SERVICE BULLETIN

EC09-001a

March 5, 2010

EVAP LEAK DTC DIAGNOSIS

REPAIR FLOW CHART

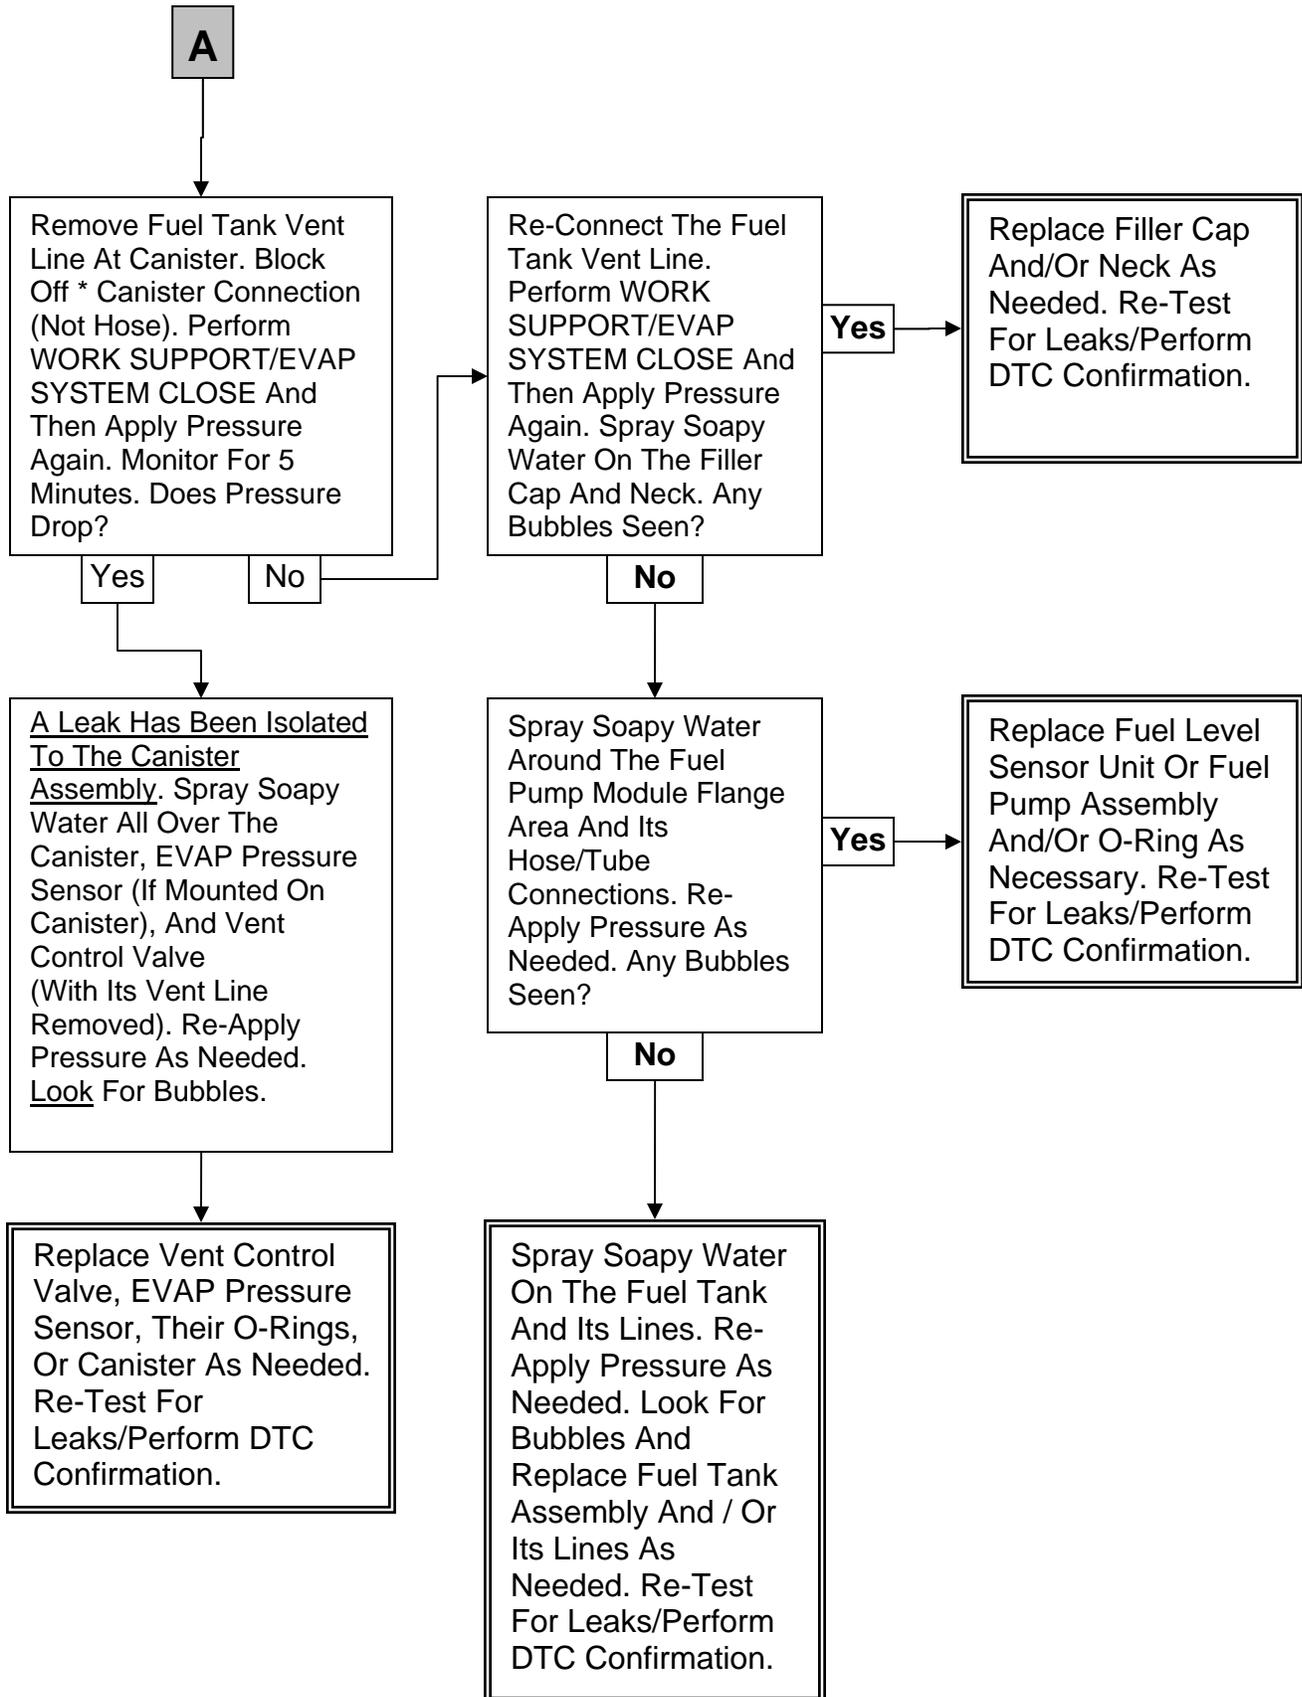
This bulletin has been amended. The REPAIR FLOW CHART has been amended. CLAIMS INFORMATION has been added. Please discard all previous copies.
